## RAVENSWORTH OPERATIONS PROJECT

### Revised Final Landform Modification (MP 09\_0176 MOD 2)

**Figure 3: Proposed Final Landform**

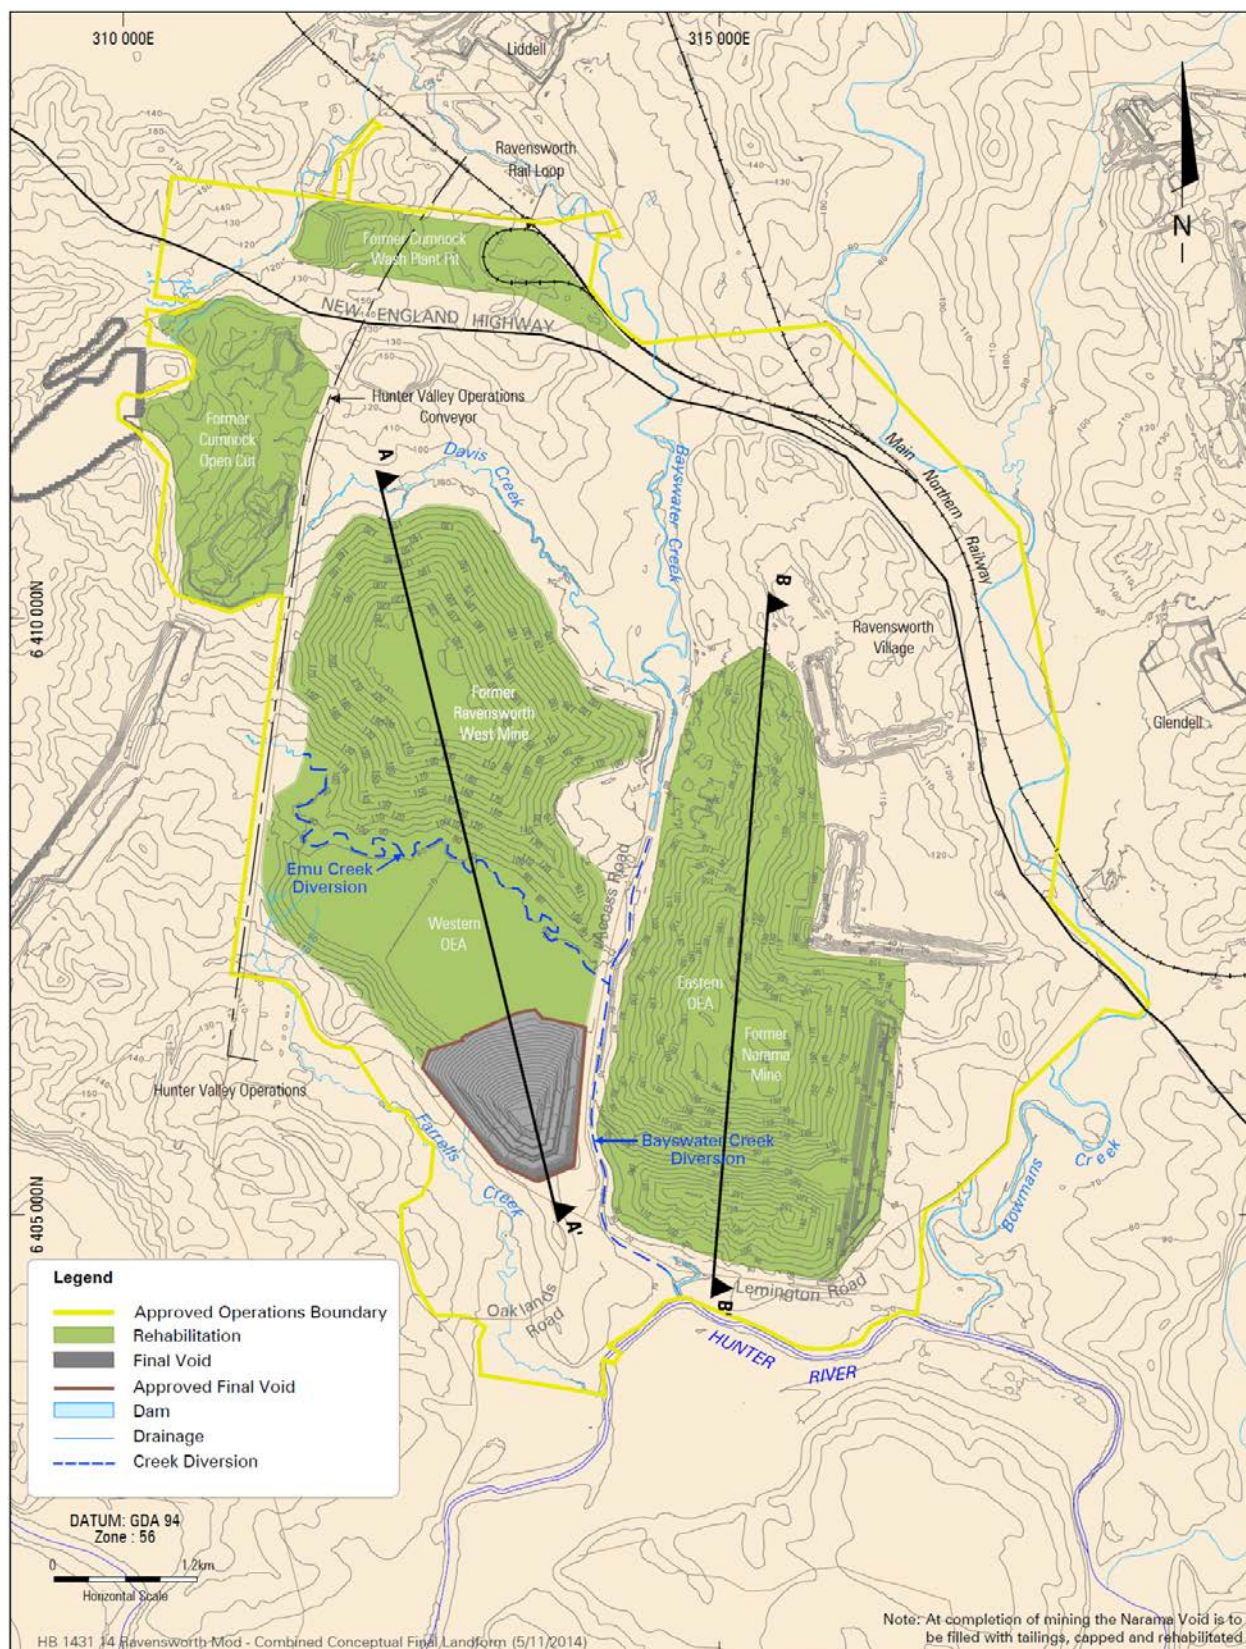
Detailed overburden emplacement analysis completed by Ravensworth indicates that the only feasible way to achieve this is by increasing the maximum height of the emplacement areas in some locations, and decreasing it in other locations (see Figure 3 and 4).

Consequently, under the proposed modification Ravensworth has requested approval to increase the maximum height of the eastern and western emplacement areas by 30 metres (m). The eastern OEA would increase from 160 m Reduced Level (RL) to 190 m RL and the western OEA would increase from 200 m RL to 230 m RL.

The Department has drafted a recommended notice of modification (see Appendix A) for the proposed modification as well as a consolidated version of the project approval as modified (see Appendix B). In summary, these conditions allow Ravensworth to construct the eastern and western overburden emplacements to a maximum height of 190 m RL and 230 m RL respectively.
